March 16, 2017

Warren Goetsch & Doug Owens
Illinois Dept of Agriculture
P.O. Box 19281, Springfield, IL 62794-9281

The points listed below highlight the omissions and inaccuracies in the applicant's setback map and its related documents submitted by Memory Lane Acres, LLC in their "Intent to Construct." These points have been aligned with Exhibits A, B, and C on pages 3, 4, and 5 respectively.

Exhibit A: Isabel Township Plat Map (2017 Publication)

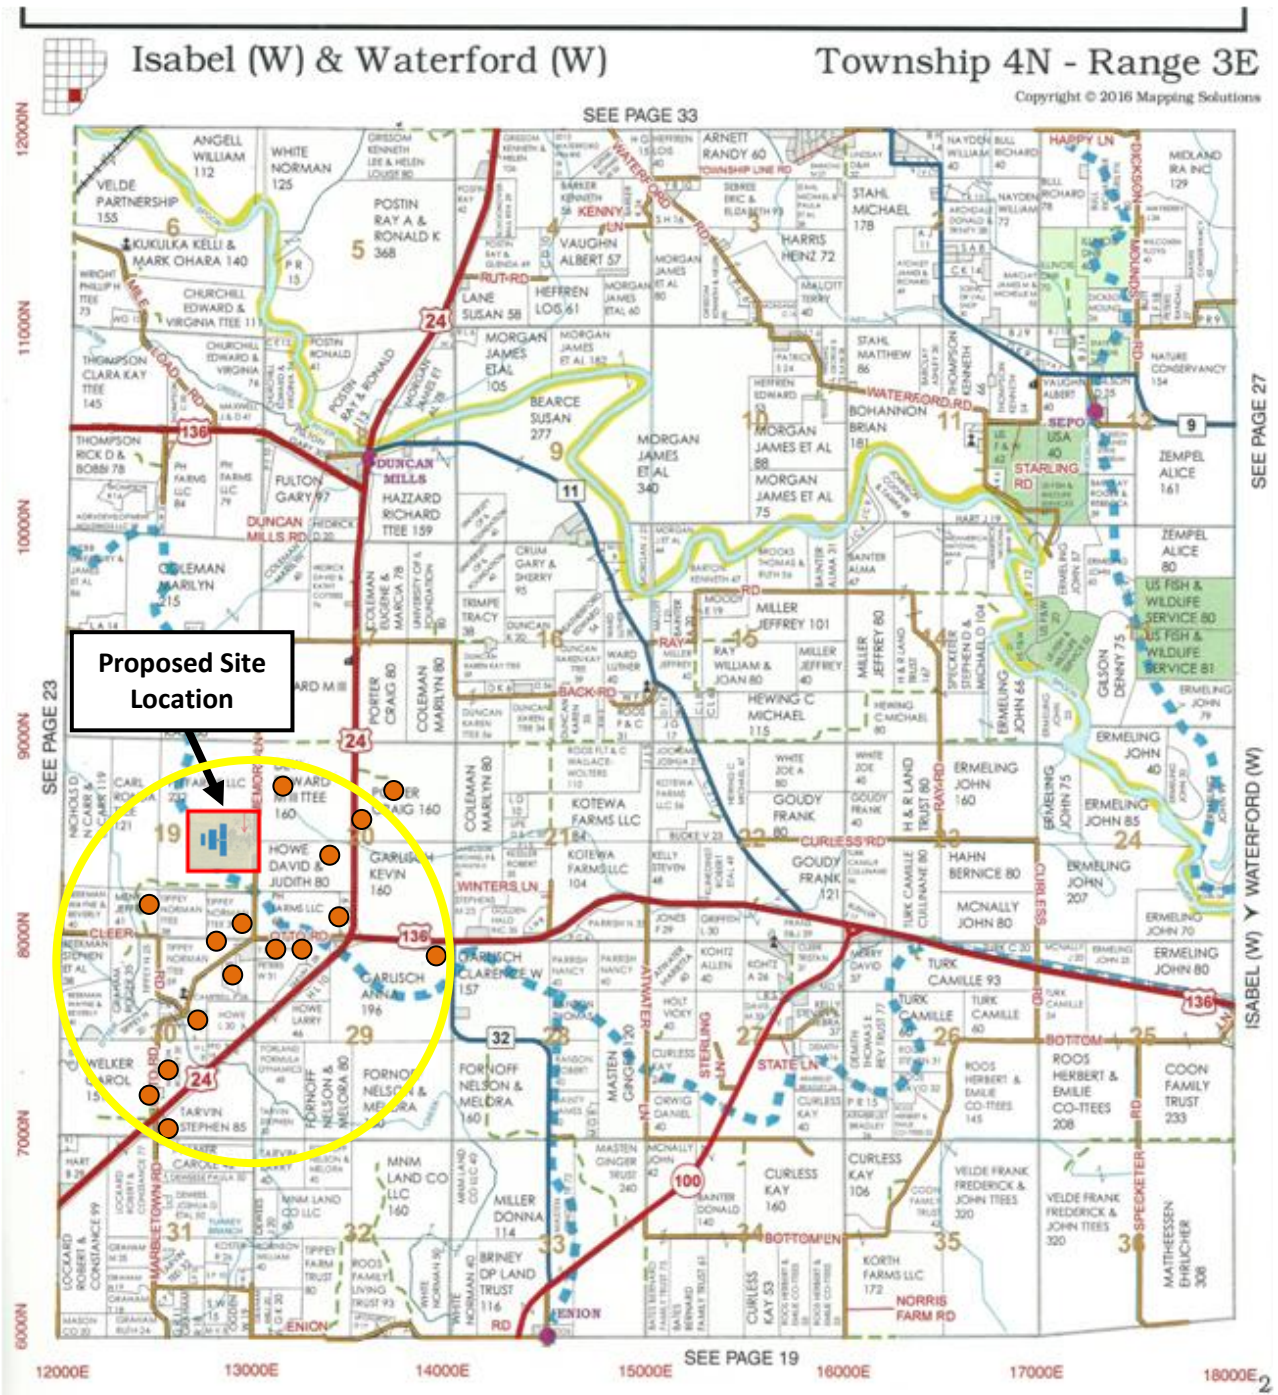
Point #1 - The Isabel Township plat map (2017 publication) included as Exhibit A shows there are more than 10 occupied residences comprising a populated area as outlined in the Livestock Management Facilities Act (LMFA). The Memory Lane facility will be located less than one-half mile from the populated area comprised of more than 10 occupied residences. The application for this site must be denied.

Exhibit B: Edited Setback Map (Edited by neighbors)

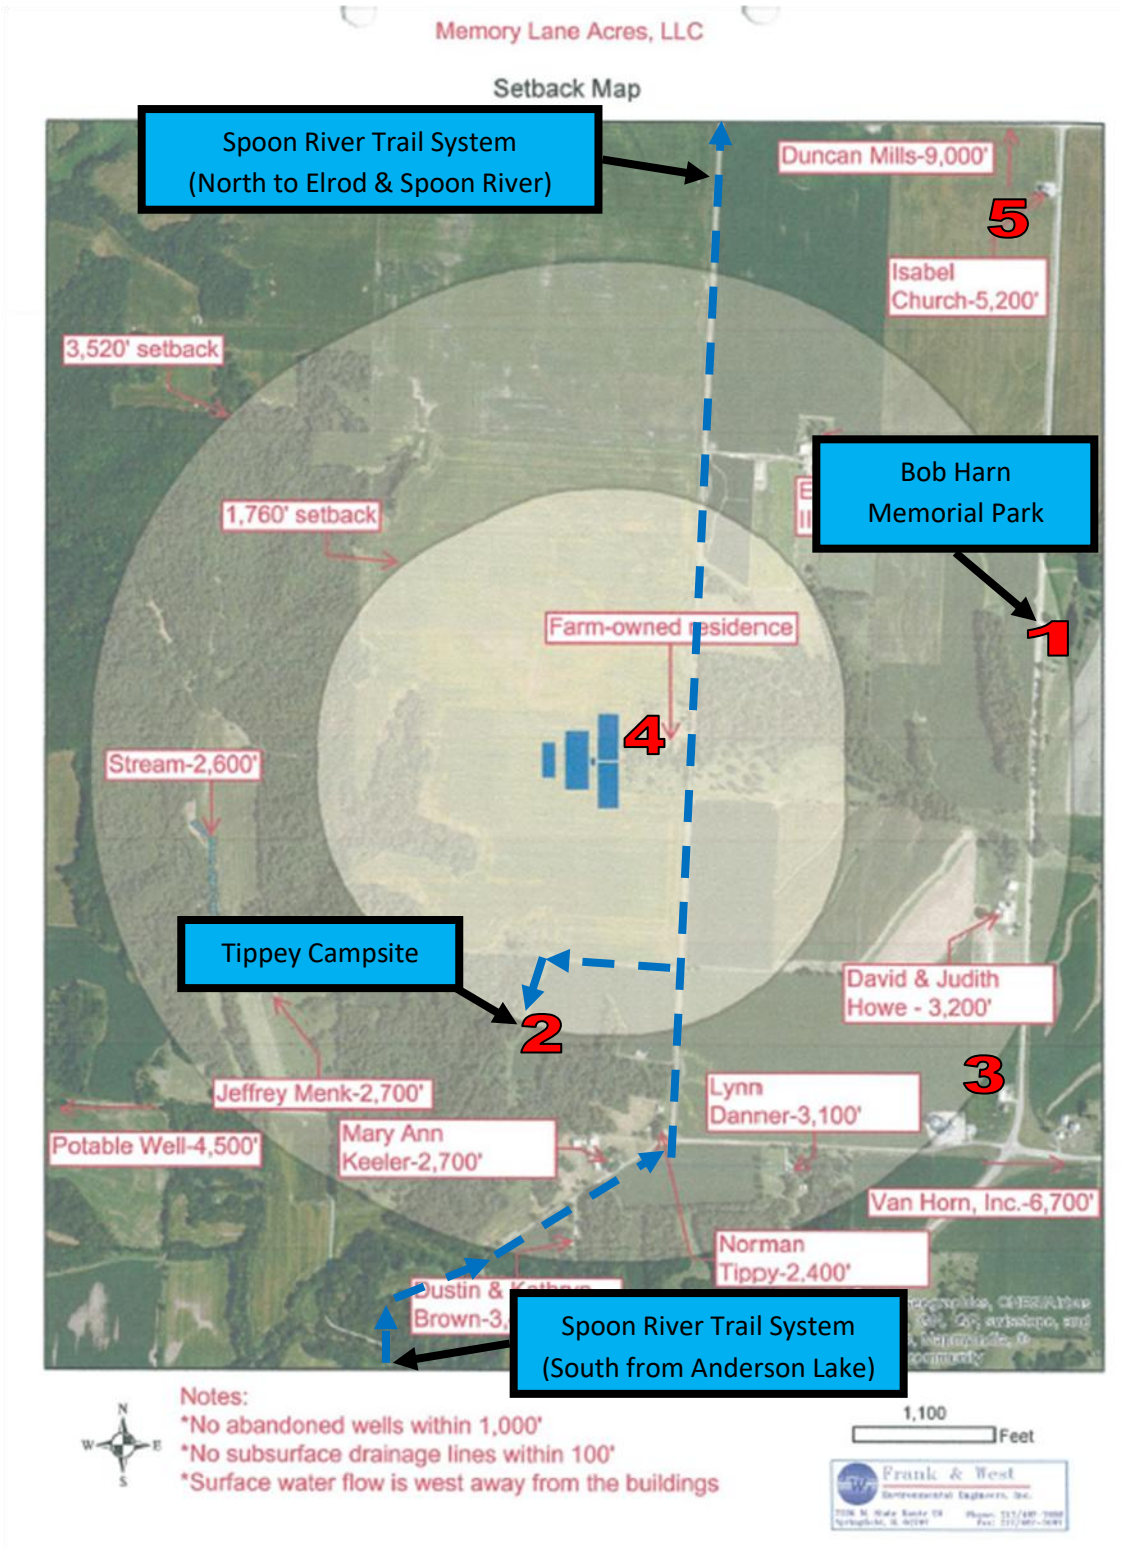
Point #2 - The area we have marked as map number 1 on Exhibit B (Bob Harn Memorial Park) qualifies under the LMFA as a populated area in that it has been used for many years as a community-gathering area visited by at least 50 people per week during the time this area is open. This location is used for community gatherings, camping, and recreational activities. This location is also a market for local vendors during the Scenic Drive Festival each fall, which would be classified as a non-farm business. This festival draws thousands of tourists to our area. It is a historical event in Fulton County that will be celebrating its 50th anniversary this year. We will provide the names of those who have used the park in the past and those who use it in the future at the Department's request. The existence of this common place of assembly and non-farm business within the setback for a populated area requires that the Department deny the application at this time.

Point #3 - The blue dashed line on the map in Exhibit B shows the Spoon River Trail System hiking path Boy Scout troops follow through this township as they travel from Anderson Lake in southern Isabel Township to Elrod on the Spoon River. The area we have marked as map number 2 on Exhibit B (Tippey Campsite) is used for overnight camping by Boy Scout troops during their hiking treks through Isabel Township. During the time this campsite is open, it is attended by at least 50 people. This qualifies the area as a common place of assembly under the LMFA located within the setback area and requires the Department to deny the application.

Point #4 - VanHorn is listed on the applicant's map as the closest non-farm business, but the company is no longer in business at that location. Map number 3 on Exhibit B indicates the location of a non-farm business. This business deals in antiques and collectibles with steady business especially during the weekends of the Spoon River Scenic Drive each October. This non-farm business is in the populated area outlined in Point #1 above and the facility's presence has the potential to have a negative impact on this business.

Point #7 - The original setback map incorrectly labeled the nearest potable well as 4500 feet. A potable well located adjacent to the farm-owned house [Exhibit B map number 4] appears to be within 100 feet of the facility. Further research shows there are numerous potable wells located within the 3520 foot setback for a populated area. The application for this site must be denied.

Point #9 - Isabel Church [Exhibit B, map number 5] is a historical location in our township. It was established in 1884 and has been in operation since that time. It hosts regular Sunday services and serves as a gathering place for community meetings and family celebrations. The congregation has been focusing on expanding their membership and updating the facilities. The church is located less than a mile from the facility. Its close proximity would have a negative impact on the church and its membership.

Exhibit C: Isabel Township Plat Map (2017 Publication)

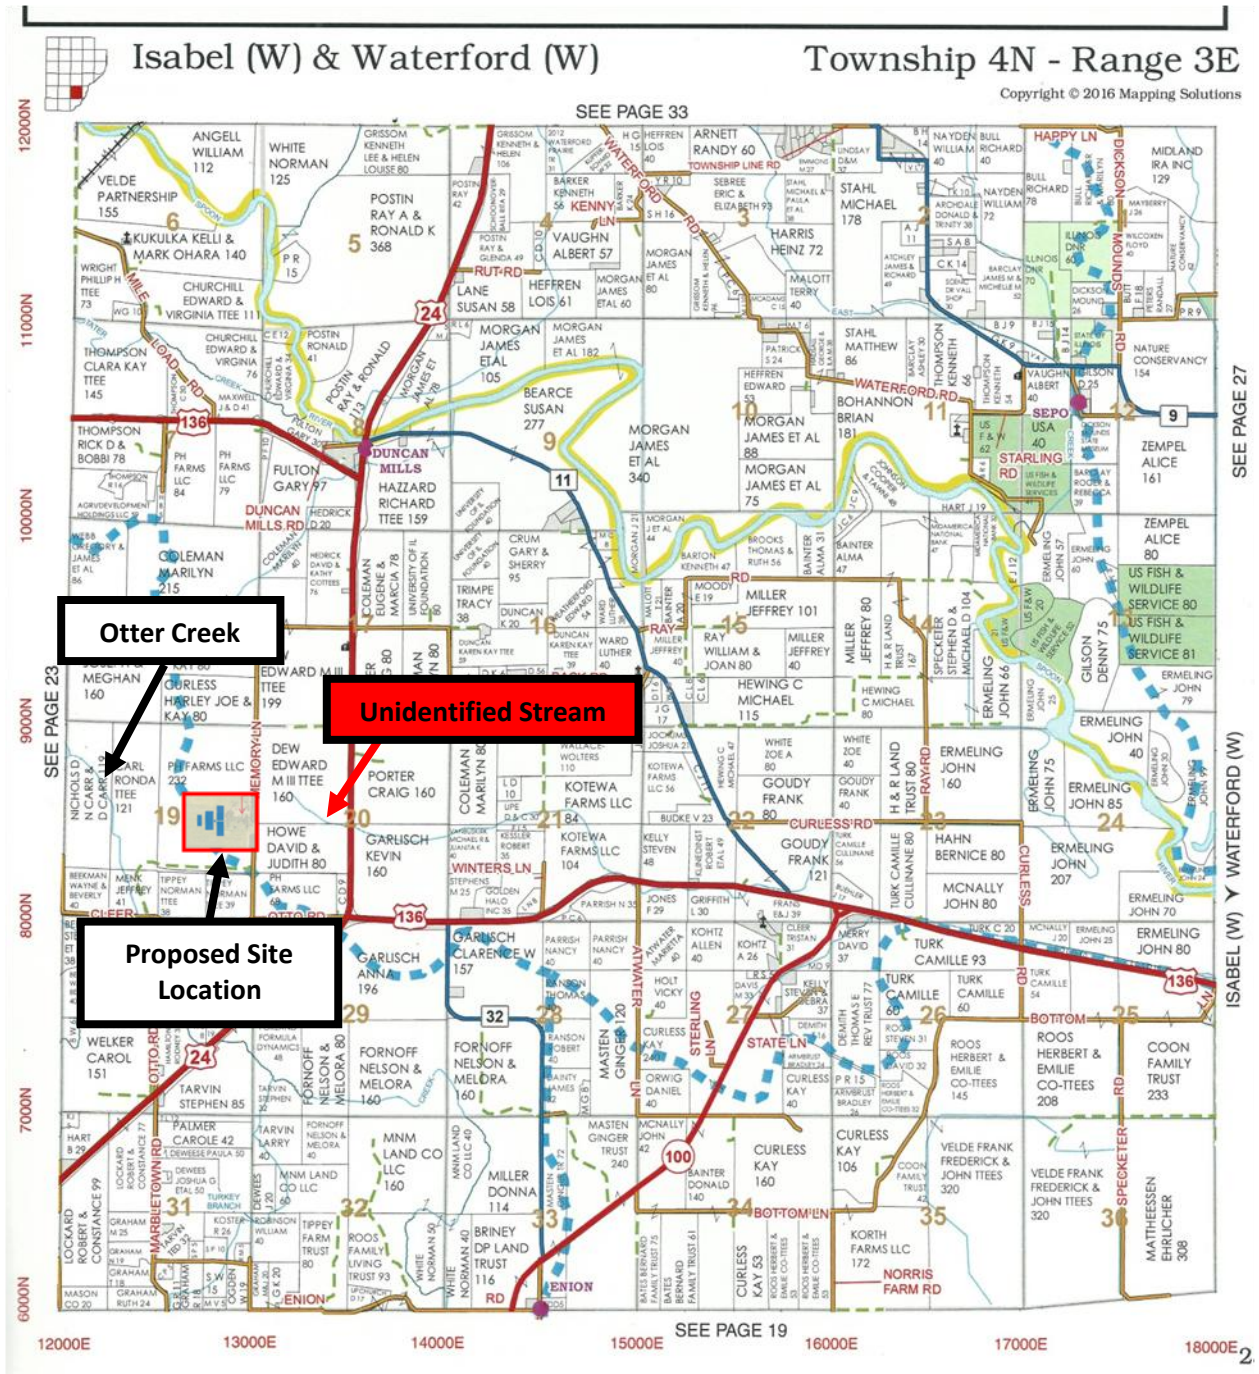
Point #8 - The Isabel Township plat map (2017 publication) shown in Exhibit C documents the location of a stream (a tributary for the Spoon River) that flows all 12 months of the year and is not shown on the original setback map. This stream is EAST of the proposed facility and is not Otter Creek, the one to the west of the facility marked as "Stream" on the applicant's original setback map and labeled on the edited setback map in Exhibit C with a red arrow. This stream begins in the middle of the Memory Lane project property and travels to the EAST to the Spoon River. The dashed blue line on the Isabel Township plat map in Exhibit C shows the topography of the land to verify the eastward flow of water in this location. In addition, existing subsurface tiles installed in 1996 by a previous owner of this land run from west-to-east under the property as well as from north-and-south along Memory Lane. Both of these subsurface tile systems feed the stream which serves as an important water source for livestock on adjacent farms. The statement on the original setback map regarding the "surface water flow is west away from the buildings" is incorrect based on this data. Also, the presence of the subsurface drainage lines within 100 feet of the proposed facility contradicts the statement "there are no subsurface drainage lines within 100 feet". The application for this site must be denied because there are subsurface drainage lines within 100 feet of the proposed facility.
